Cheltenham Drive Bikeway MR2026005

Mandatory Referral Notice – MR2026005

Cheltenham Drive Bikeway

Re: December 11, 2025, Item 4 (Cheltenham Drive Bikeway Mandatory Referral);
Bethesda Downtown Implementation Advisory Committee's Written Comments
Requesting Changes

Proposed plans – issues with head-on lane orientation and corner islands:

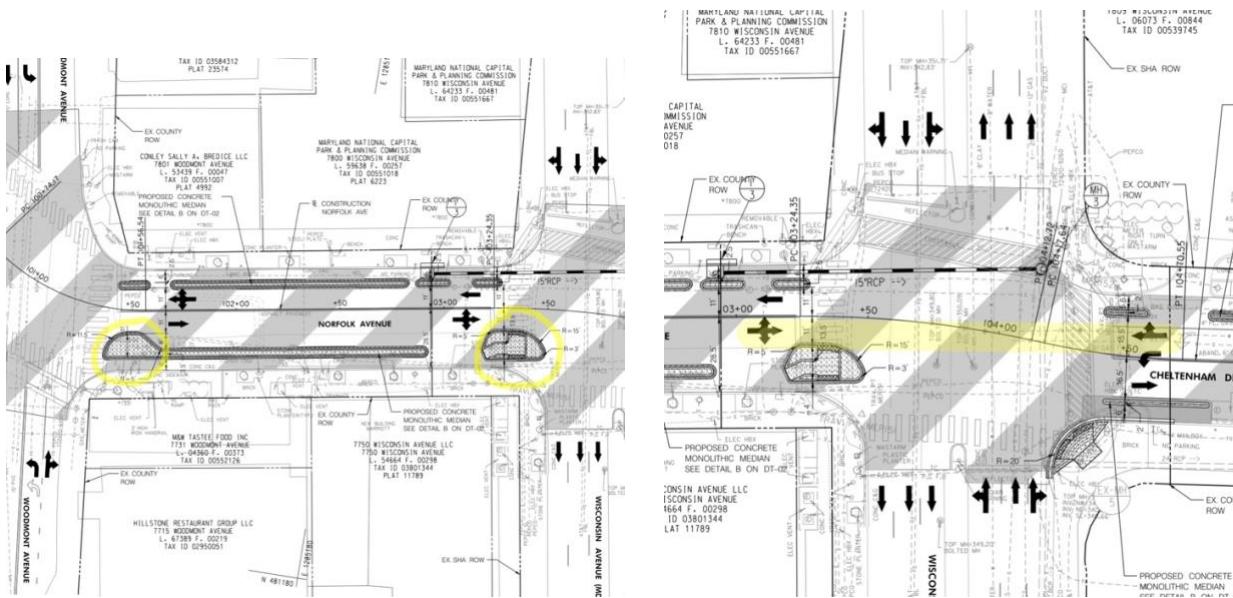
We very much appreciate the efforts made by MCDOT to provide safer infrastructure for bicyclists and pedestrians in downtown Bethesda. However, we have concerns that MCDOT's design for the Cheltenham Drive/Norfolk Ave bikeway from Tilbury Street to Woodmont Ave, as currently proposed, will create more unintended problems than true safety solutions, does not follow the recommendations set forth in the Bethesda Downtown Plan, ignores some of the on-the-ground realities and complexities, and at an estimated total cost of \$2.2 million dollars for two short blocks, will be extremely expensive to construct.

Figure 2.12: Norfolk Avenue Existing and Proposed Street Sections

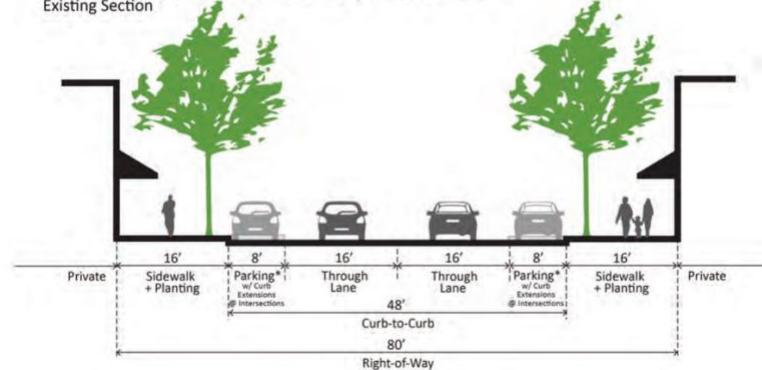
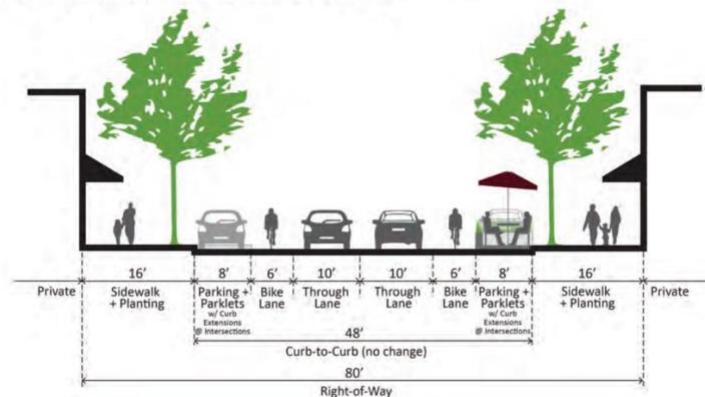
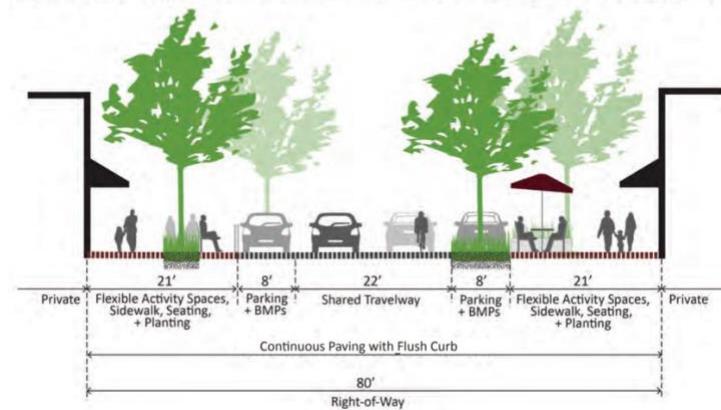
We also note that one year after the 2017 sector plan was adopted, the 2018 Bicycle Master Plan changed the designation of the Cheltenham/Norfolk bikeway/shared street with no clear explanation as to why. We request that MCDOT implement a more simplified bikeway design for Cheltenham Drive / Norfolk Ave – which may include striped bike lanes, a shared side path (such as exists along Western Avenue in Friendship Heights and elsewhere), or a two-way buffered bike lane on the north side of the street (such as exists along Woodmont Ave between Norfolk and Old Georgetown Road).

In addition, the 2017 Bethesda Downtown Plan (pages 53-54) included proposed street sections for Norfolk Ave from Rugby Ave to Wisconsin Ave which ultimately recommended a “Shared Street with Stormwater Best Management Practices” included in the study of the design.
